CITY COUNCIL REGULAR MEETING AGENDA
November 1, 2022 at 6:30 p.m.
City Hall Council Chambers and Virtual

Pedestrian Crossing Safety Project Contract P2111-22

The apparent low bid for the P2111-22 Pedestrian Crossing Safety Budget came in at \$806,459.49. The project budget is \$763,800.00. This leaves the City with a difference of \$42,659.49. The Public Works Director directed the Transportation Manager and Engineering to evaluate the plans and bid to reduce scope in order to meet budget.

SITE 5 **S5** WEST OF FILLMORE SCALE: 1" = 20'

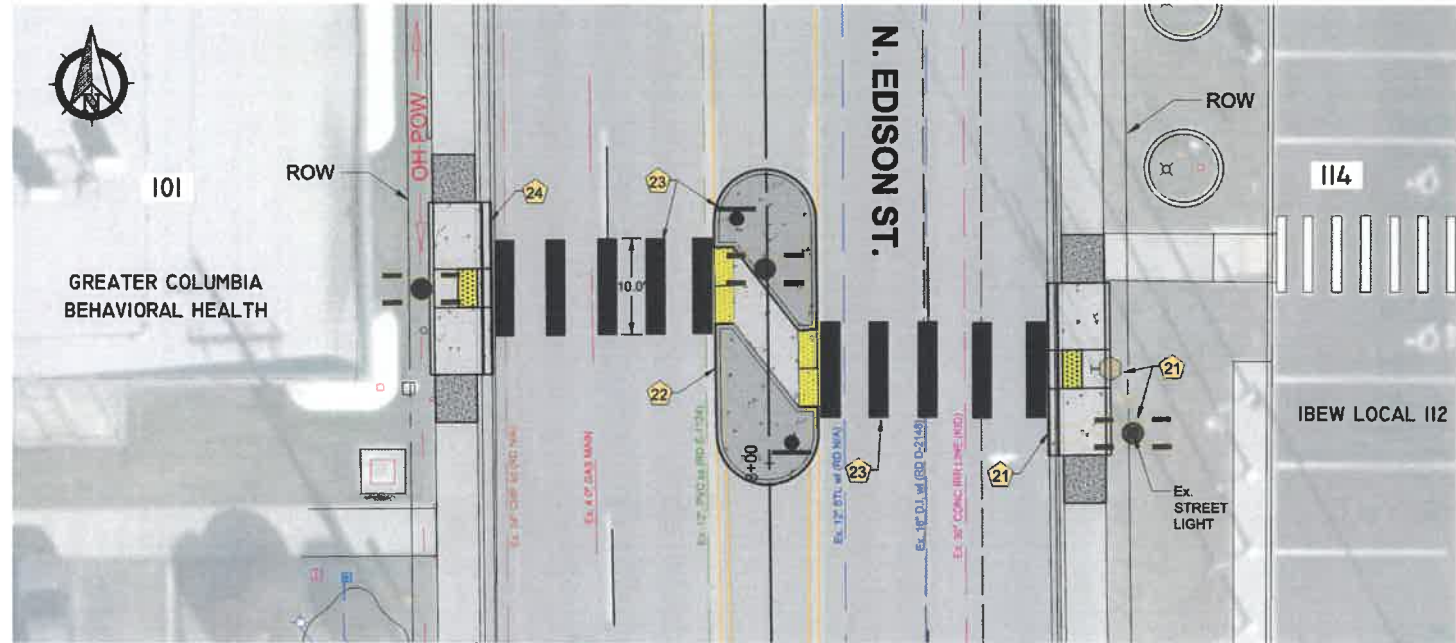
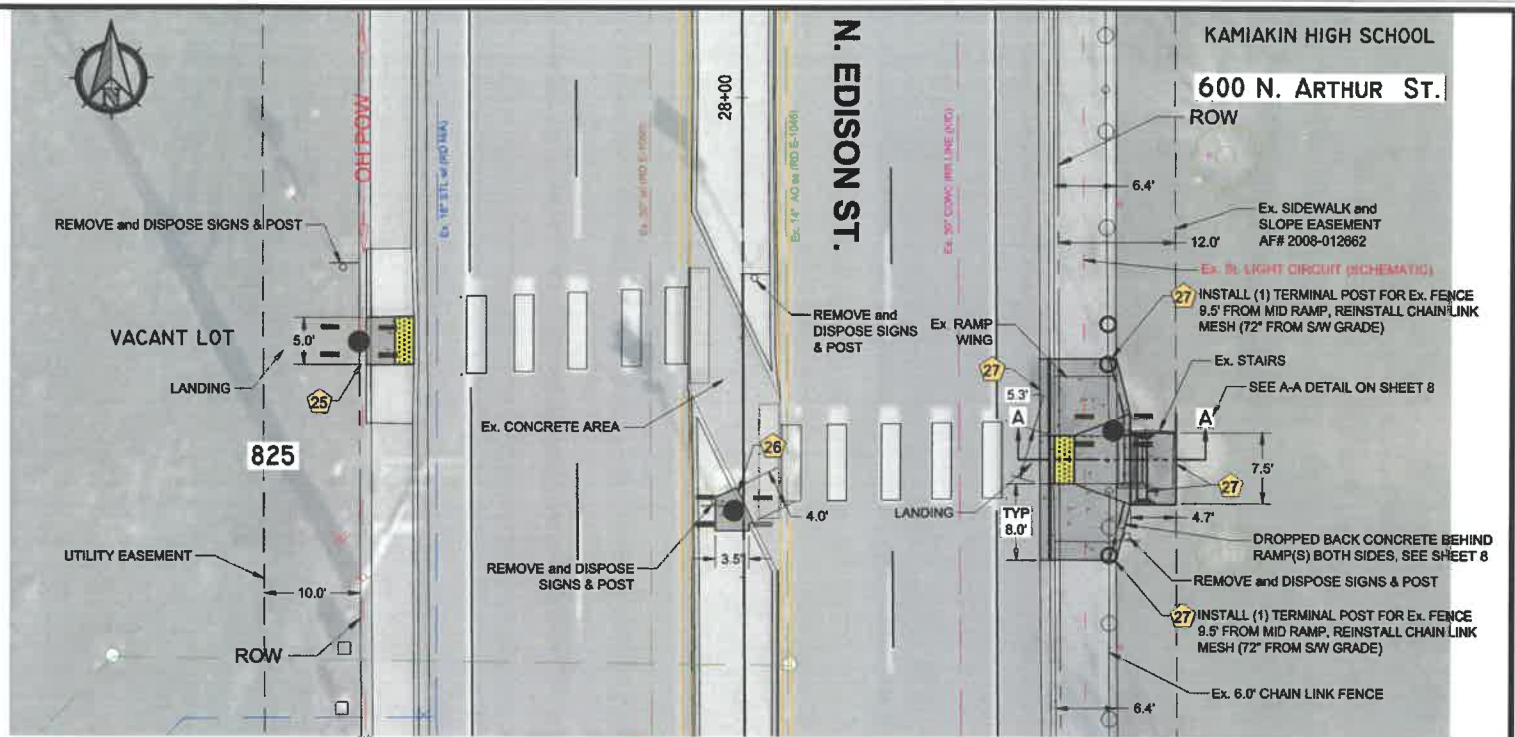
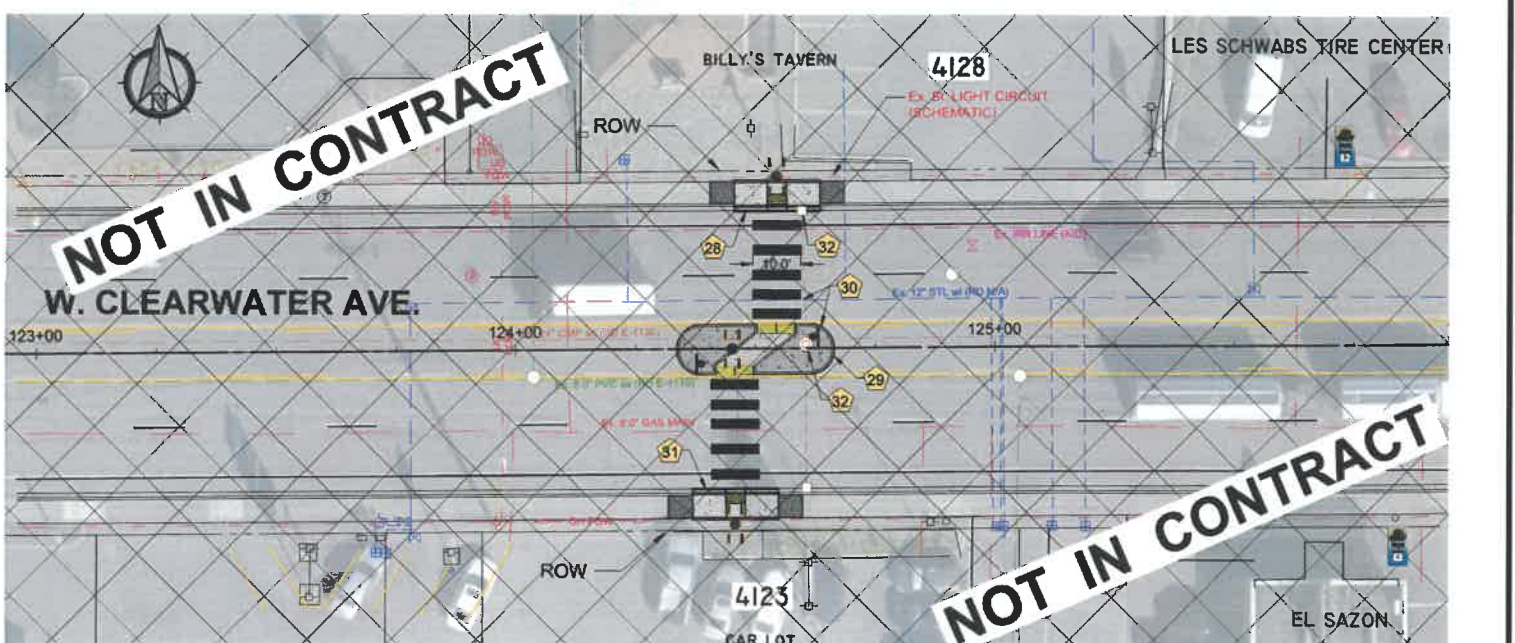
1. Site 13 Instead of replacing the two existing telespar-mounted RRFB's on Olympia with new RRFB's on 4-inch breakaway posts, just relocate these telespar-mounted RRFB's to the proposed new locations. (Cost Reduction: **\$27,721**)
2. Site 5 In the opinion of the Transportation Manager, this site is the least on the priority list since it is not near a school, and the Edison and Clearwater signalized intersection was nearby to use as a crossing. Therefore, the decision was made to remove this site in it's entirety. (Cost Reduction: **\$79,011**)

- MET WITH TRANSPORTATION MANAGER ON 10/6/22. DECISION WAS MADE TO REMOVE SITE 5 IN ORDER TO MEET BUDGET. ALSO DECIDED TO NOT REPLACE EXISTING RRFB'S AT SITE 13 ON OLYMPIA (CURRENTLY ON TELSPARS) WITH NEW POLE CONFIGURATION W/BASES.

Contract amount would be revised to **\$699,727** which would allow a **9%** contingency.

SITE 13 S13 CANYON VIEW ELEMENTARY SCALE: 1" = 10'

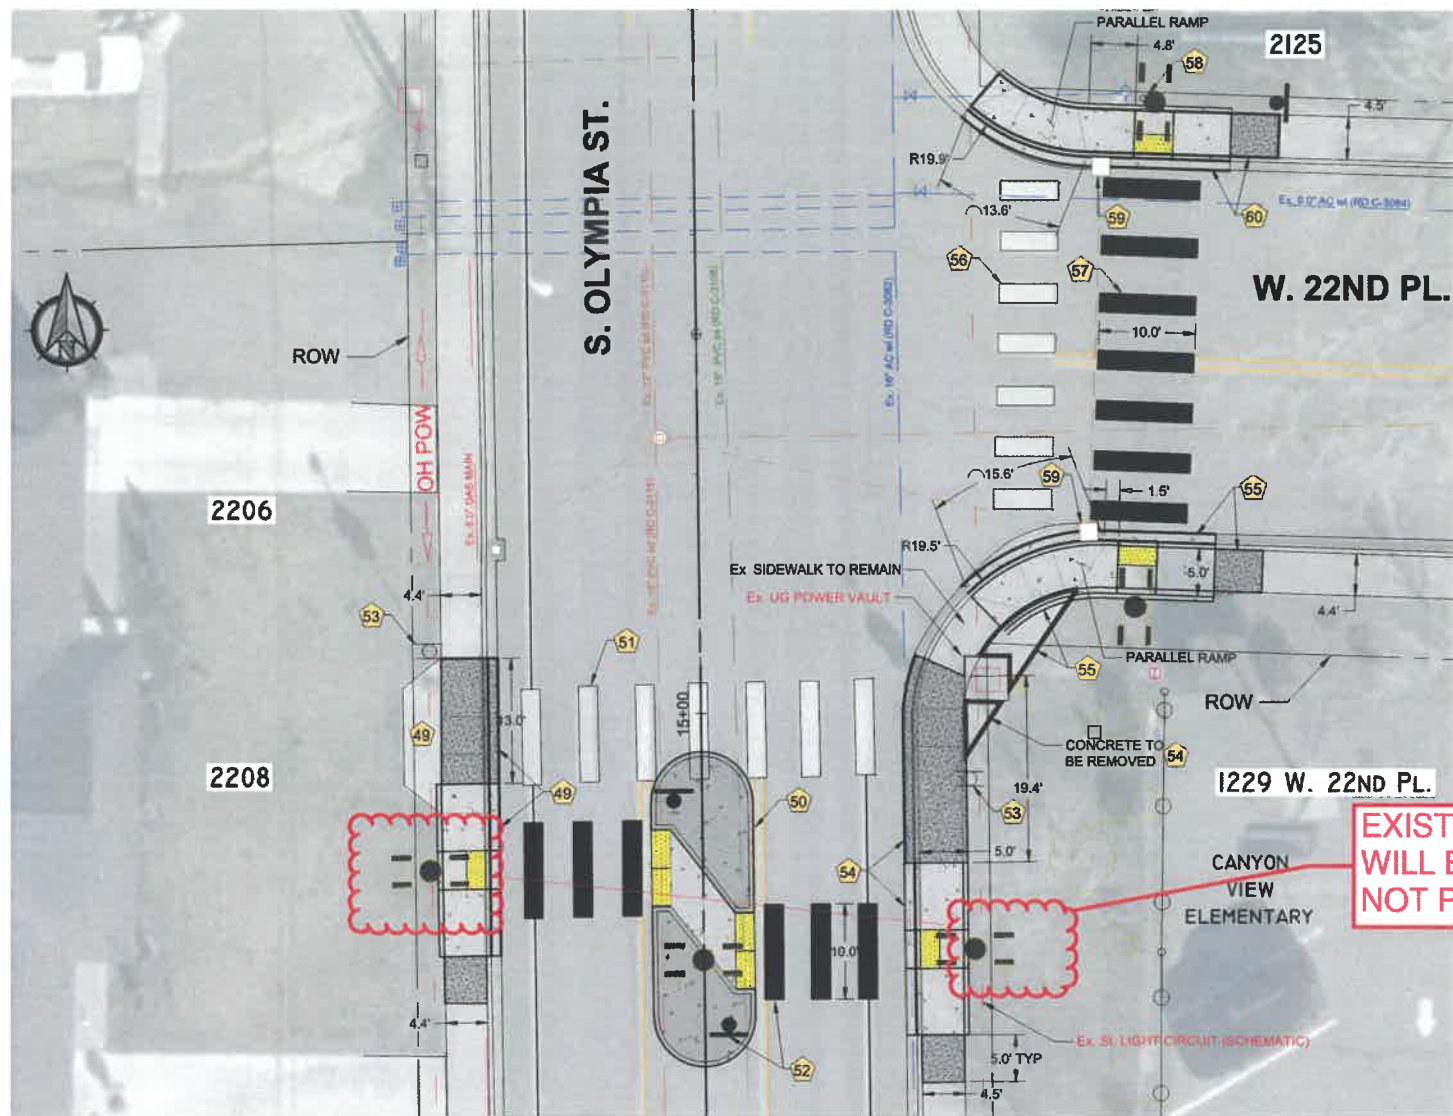
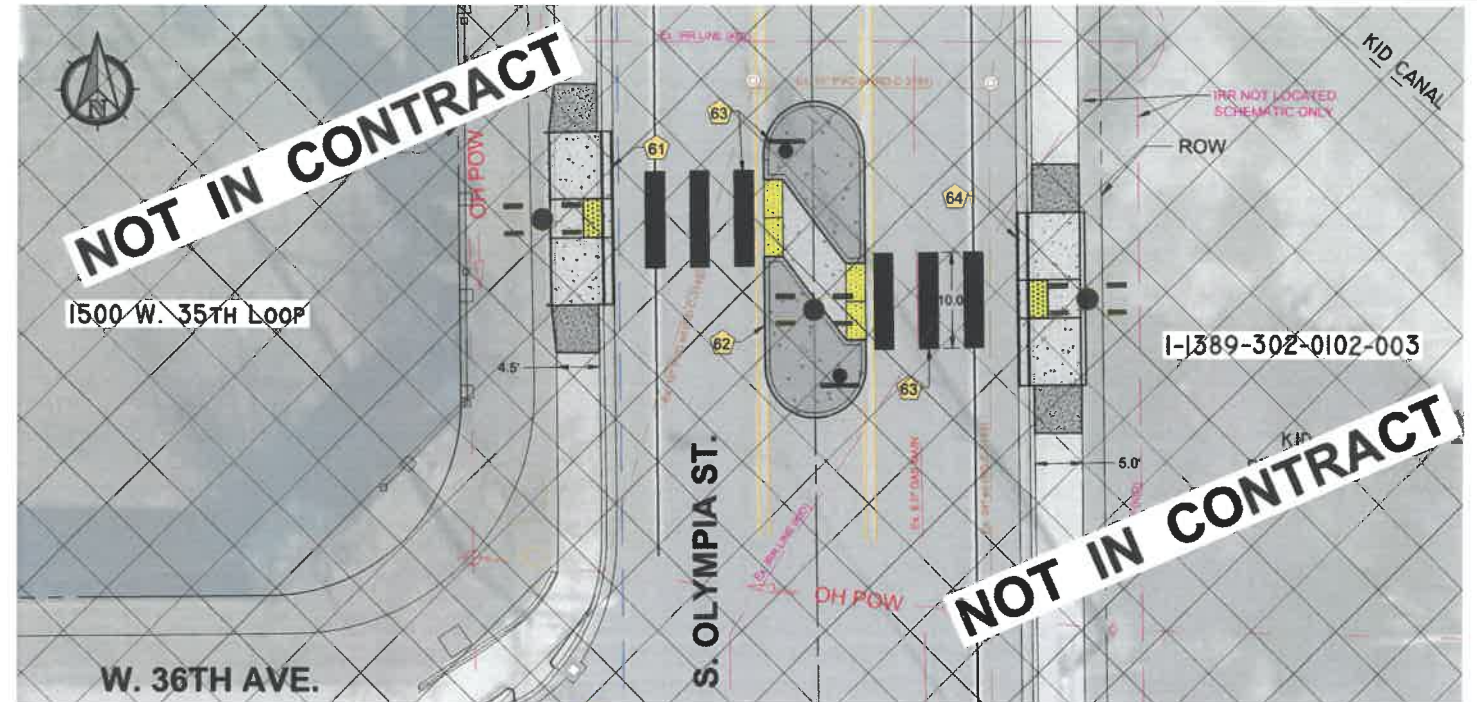
RELOCATE EXISTING
TELESPAR RRFB'S

EXISTING TELESPARS
WILL BE RELOCATED AND
NOT REPLACED.
